# STATEMENT OF RESPONSE TO AN BORD PLEANÁLA'S CONSULTATION OPINION

Cairn Homes Properties Limited.

**IN RESPECT OF A  
PROPOSED MIXED-USE DEVELOPMENT AT THE  
FORMER BLAKES, ESMONDE MOTORS SITE  
April 2022**

**Figure 2.2 – Amended Proposed Heights and Context**

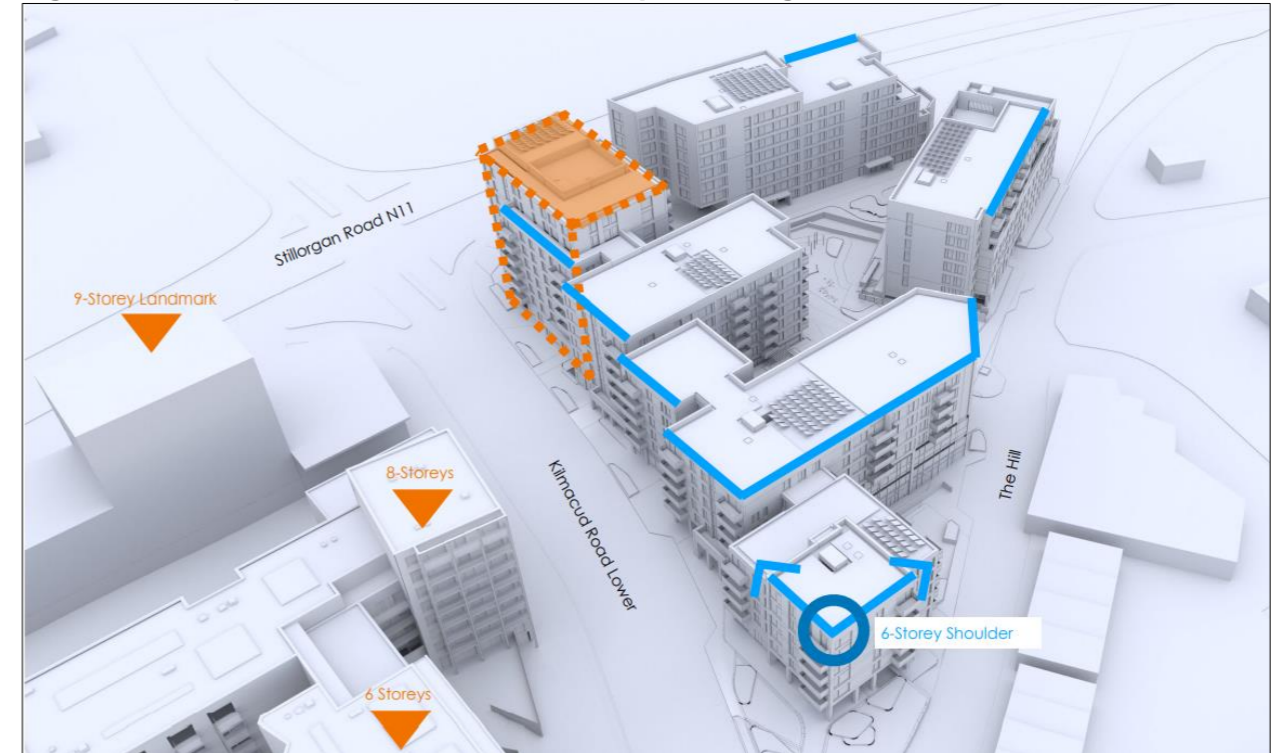
*1. Further consideration and/or justification of the documents as they relate to the height and design strategy for the site, having regard to the policies and objectives of the recently adopted Stillorgan LAP 2018; the permitted heights on this site and other sites in the general vicinity; together with the capacity of the site to accommodate a development of the height, scale and massing proposed. The applicant is referred to the recently adopted Stillorgan LAP 2018, (adopted subsequent to the granting of permission for ABP-300520-17, which permitted a maximum height of 9 storeys), in particular the 'Site Development Framework' prepared for the site (Table 4.5.3.2), contained therein. This Site Development Framework sets a benchmark height of five storeys across the site, with a landmark building of up to nine storeys at the corner of the N11/Lower Kilmacud Road junction. This landmark height reflects the height of the previously permitted development on the site (ABP-300520-17). In this regard, the prospective applicant should satisfy themselves that the design strategy for the site as it relates to height provides the optimal architectural solution for this site, in line with both local and national policy, and should submit rationale/justification for the heights/setbacks proposed. CGIs, visualisations and cross sections, as necessary, should be submitted which clearly show the relationship between the proposed development and existing/permitted development in the immediate and wider area and which illustrates the topography of the area. The further consideration of these issues may require an amendment to the documents and/or design proposals submitted at application stage.*

2.4 In response to Item no. 1, the proposed height and design strategy of the site has been reviewed and it is now proposed to provide a landmark building of 9 no. storeys in place of the previously proposed 15 no. storeys. The overall number of apartments has been significantly reduced by 87 no. from 464 no. to 377 no. units

2.8 The OMP ABP Response Document notes that the development consists of 6no. buildings ranging in height from 3-9 storeys. The proposed heights are informed by the Stillorgan LAP rising toward a 9-storey landmark building at the N11 junction / Northeast corner of the site. Buildings to Kilmacud Road Lower range in height from 5/6-7 storeys. A shoulder height is established by these buildings resulting in an additional floor to Building 03 as the ground plane falls away toward to the N11.

**Figure 3.1 – Materials**

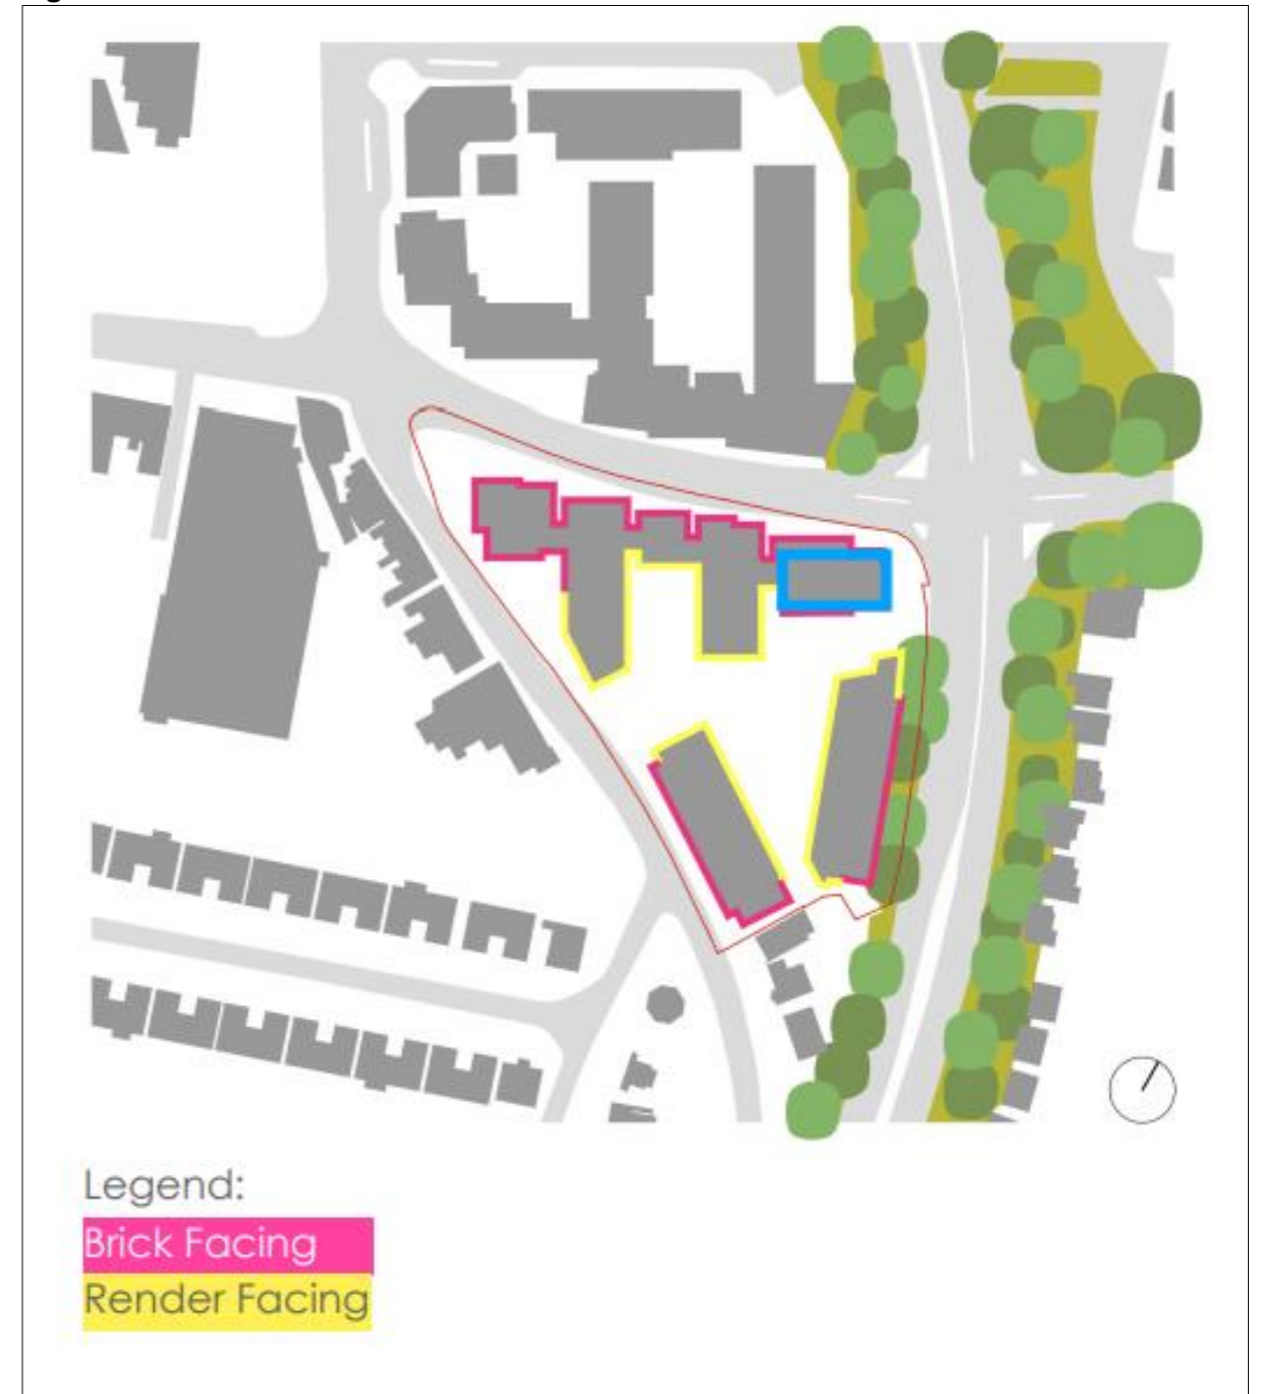
*“1. A report that specifically addresses the proposed materials and finishes of the proposed structures including specific detailing of finishes, openings, the treatment of balconies, landscaped areas and boundary treatments. Particular regard should be had to the requirement to provide high quality and sustainable finishes and details which seek to create a distinctive character for the development. Particular regard should also be had to details showing proposals for the treatment of the interface between the proposed buildings, private/communal open spaces and public realm. Pedestrian permeability through the site should be outlined. The applicant should note the provisions of the Stillorgan Village Area Movement Framework Plan (SVAMFP) (2017) in this regard. The documents should also have regard to the long-term management and maintenance of the proposed development. Additional cross sections, CGIs and visualisations should be included in this regard.”*

3.3 In relation to Issue No.1, we refer the Board to the An Bord Pleanála Response prepared by OMP Architects. Section 4.1 of the OMP response sets out the material strategy. In addition, the Kevin Fitzpatrick Landscape Architects Design Report and drawings show detail of the public realm, open spaces as well as landscaped areas and boundary treatment.

**Figure 3.5 – Refuse Areas and Waste Marshalling Area**

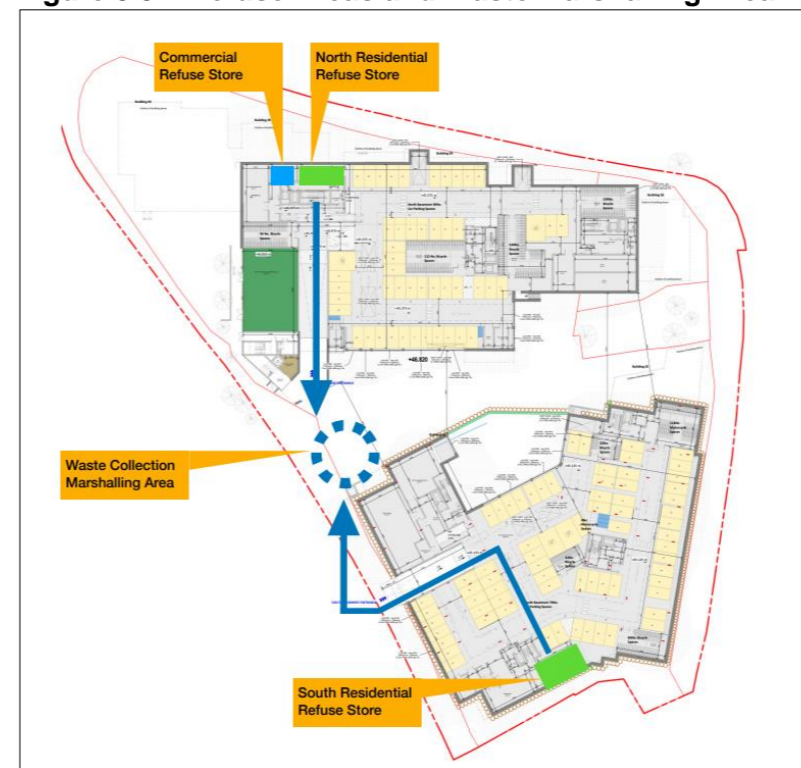
*“2. Additional transportation details for the site having regard to the requirements of the Transportation Planning Division as indicated in their report, dated 04th August 2020, contained in Appendix B of the Planning Authority's Opinion.”*

3.15 As set out in the Waterman Moylan TTA, servicing and deliveries will be accommodated on the Hill. Waste storage for the residential blocks will be located in the basement under each block. A centralised waste storage area with access from ground level will be provided for the non-residential elements of the development. Bins will be collected weekly from the bin collection area on The Hill.

**Figure 3.11 – Separation Distances**

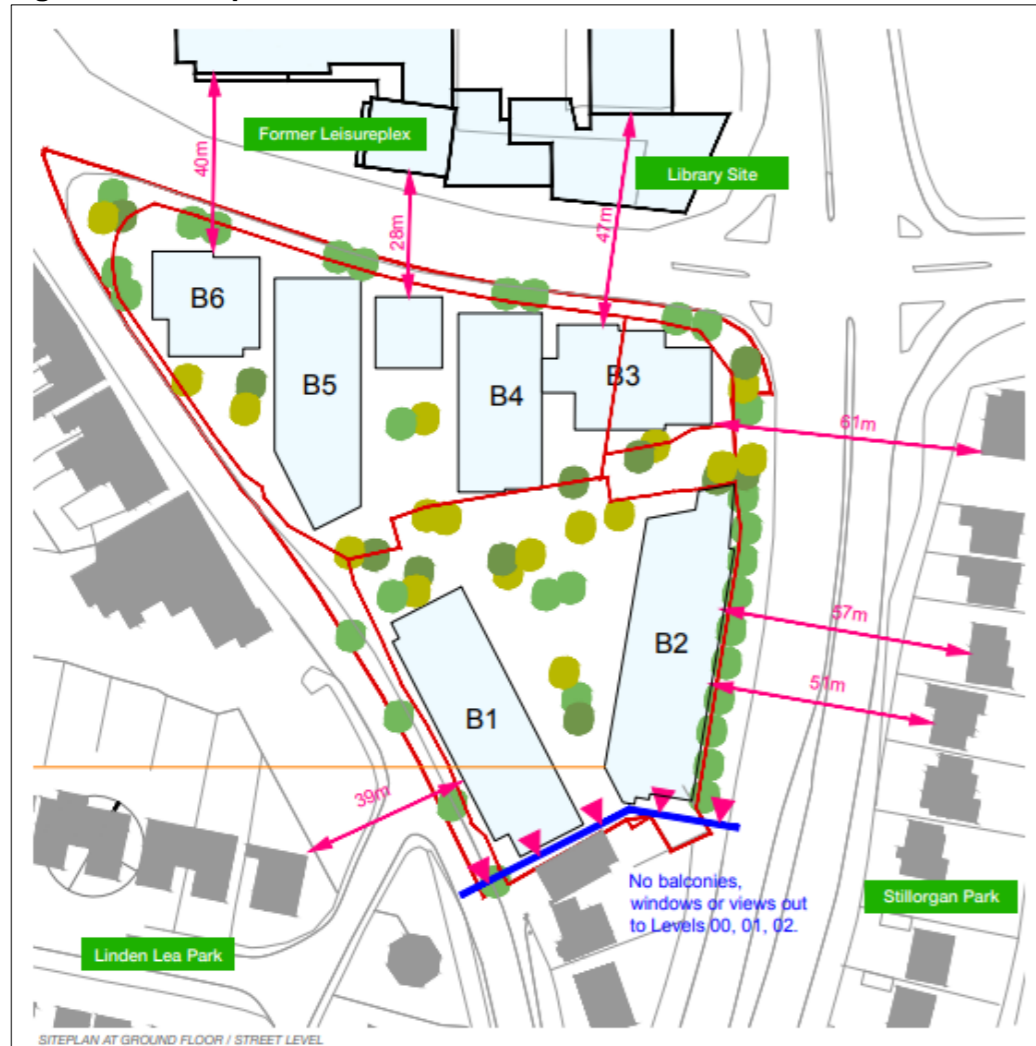
*“5. A report that addresses issues of residential amenity (for existing residents of adjoining development, future occupants of proposed scheme and future residents of permitted but not yet constructed development in vicinity), specifically with regards to overlooking, overshadowing, overbearing and noise. The report shall include full and complete drawings including levels and cross-sections showing the relationship between the proposed development and adjoining residential development. Furthermore, landscape and architectural drawings that clearly detail the relationship between wind impact mitigation measures and the design of the proposed development shall be included.”*

3.80 As outlined in the OMP ABP response document, residential amenity has been carefully considered and informs the urban response and form of the scheme. Consideration has been given to:
